**TRANSITIONAL PART 3A PROJECT
ASSESSMENT:
Shaolin Tourist & Residential Development
Comberton Grange South Nowra
(MP06_0135)**

Secretary's
Environmental Assessment Report
Section 75I of the
Environmental Planning and Assessment Act 1979

July 2014

Figure 9: Proposed Vegetation Removal from the Jervis Bay REP Habitat Corridor (Source: Environmental Assessment)

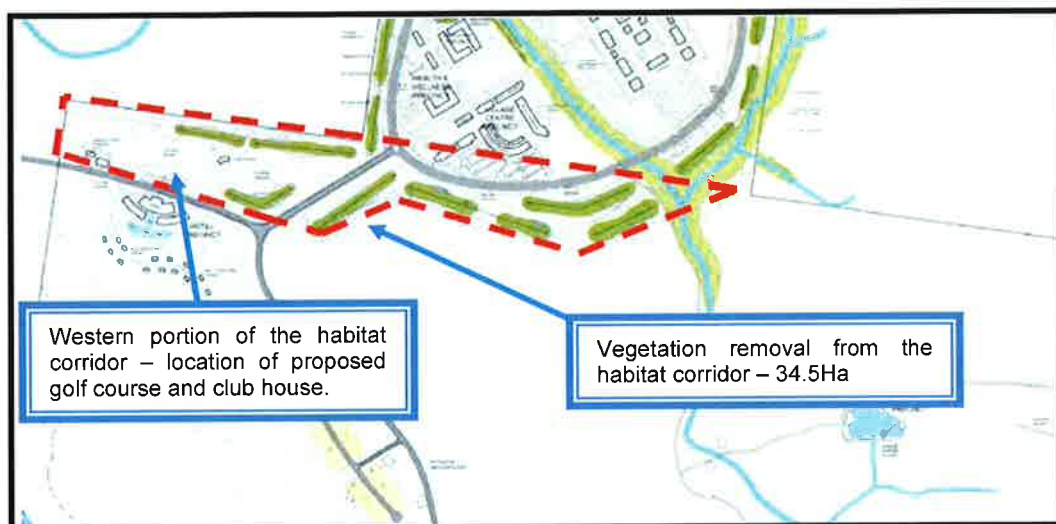
OEH and Council raised concerns with the adequacy of the biodiversity assessment, citing inadequate survey effort and insufficient detail to adequately assess the impacts of the Project. Specifically, OEH stated that there was insufficient survey for a number of threatened and endangered species and insufficient survey of feed trees for the Yellow-bellied Glider. The RtS did not provide any additional surveys to address the inadequacies identified by OEH and Council, however the Proponent stated that the proposed development area would be unlikely to support suitable habitat and had specifically avoided sensitive areas such as the riparian and wetland habitats.

- clearing of 34.5 hectares of native vegetation in the central and western part of the site for construction of the golf course and part of the Village Centre Precinct (see **Figure 9**). This area is identified as 'habitat corridor' in the Jervis Bay REP;

While the Department is satisfied that an adequate level of assessment has been carried out to support the Concept Plan, including the siting of the development component on the least sensitive land, the department notes that further detailed survey and assessment is required in order to fully quantify the impacts and refine appropriate mitigation measures. The department notes that separate development applications would be submitted and assessed for the physical works associated with the Concept Plan, and has recommended that detailed biodiversity surveys and assessment be carried out prior to lodging the first development application for the site. The department also recommends that as part of this assessment, the required biodiversity offset for the Project is determined utilising the Biobanking Assessment Methodology and that a Biobanking Agreement is in place, prior to submission of the first development application. This assessment is also required to be prepared in consultation with OEH and the Council, and to the satisfaction of the Secretary. The OEH has accepted this approach.

Figure 13: Proposed Grade Separated Interchange (Princes Highway/Forest Road) (Source: Traffic Impact Assessment prepared by Lyle Marshall & Associates P/L, dated March 2012)

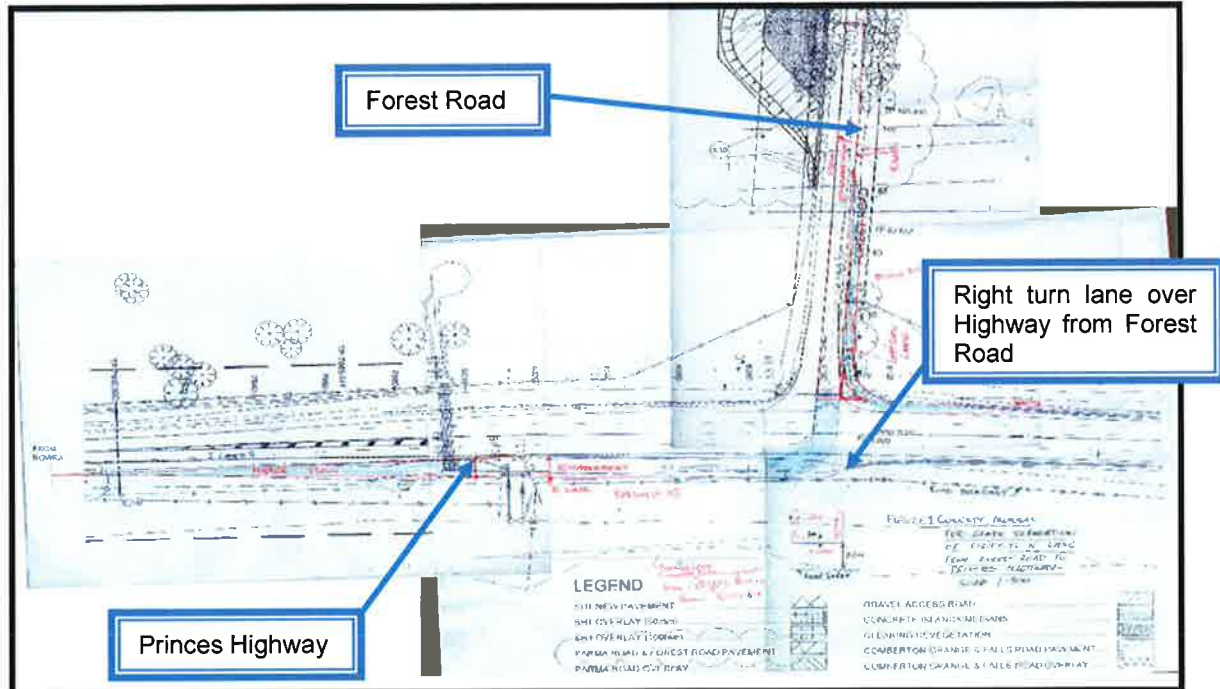
The RMS objected to the proposed traffic signals at the intersections of the Princes Highway and Forest Road and advised that it will not provide the necessary approvals required under Section 87 and Section 138 of the *Roads Act 1993*. The RMS stated that this intersection is within a 100km/hr speed zone where traffic signals are not permitted and reducing the existing 100km/hr speed zone at this location to allow for the signals for an isolated development would not be supported.

The RMS has maintained that a grade separated interchange is required for the right turn from Forest Road onto the Princes Highway at this intersection to cater for the significant increase in traffic volumes through this junction as a result of the proposed development. This treatment is required to maximise road safety and traffic level of service through the intersection.

Stage 2 of the project should not proceed without the grade separated interchange given the likely significant safety impacts that would result at the Princes Highway/Forest Road intersection. The commitment to construct the grade separated interchange satisfies these concerns and therefore forms part of the recommended modifications/terms of approval as well as requirements for future applications within the Concept Plan approval. The detailed design of the interchange can occur with subsequent development applications. The traffic modelling requirements of the RMS have also been considered and are addressed in the recommended Concept Plan approval. The construction of the grade separated interchange will be subject to a separate application and environmental assessment under Part 4 or 5 of the EP&A Act (where relevant).

- demonstrate that the existing intersection can accommodate the traffic associated with Stage 1 and to include recommended further upgrade works if required for Stage 1;
- demonstrate that the proposed interchange design can accommodate traffic associated with the ultimate project; and
- include a scaled conceptual plan of the proposed interchange and demonstrate it can be constructed in accordance with the Austroads Guide to Road Design.

Figure 15: Proposed Zoning Regime by the Proponent
 (Source: Response to Submissions, Conybeare Morrison, December 2013)

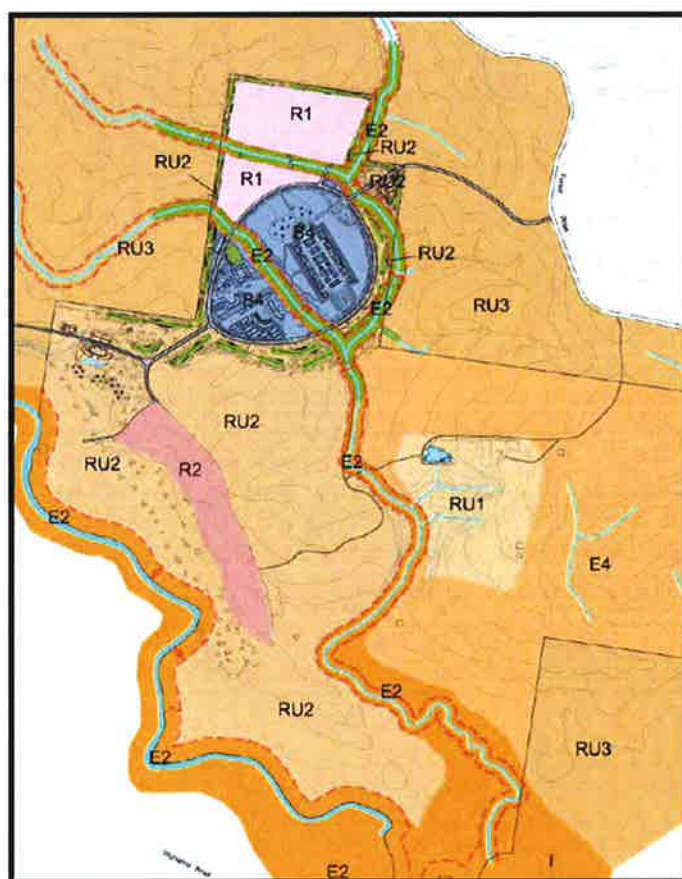
These proposed zones are illustrated in Figure 15. This proposed rezoning regime is significantly different to the zoning under the Shoalhaven LEP 2014. In general, the zoning regime proposed by the Proponent is not supported by the department, as outlined below.

It is therefore considered that the Proponent's proposed zoning of portions of the site to R1, R2 and B4 is inconsistent with the Panel's recommendations, the Regional Strategy and the key planning issues identified by the Panel in its assessment of future development on the site.

Overall, the department considers that the proponent's proposed zoning regime is not consistent with either the Shoalhaven LEP 2014 or the Panel's key recommendations (see Table 3). This view was supported by Shoalhaven Council and a number of agencies. As such, the Department does not support the proposed zoning changes and has recommended that a modification to the Concept Plan is imposed which does not approve this aspect of the Concept Plan.
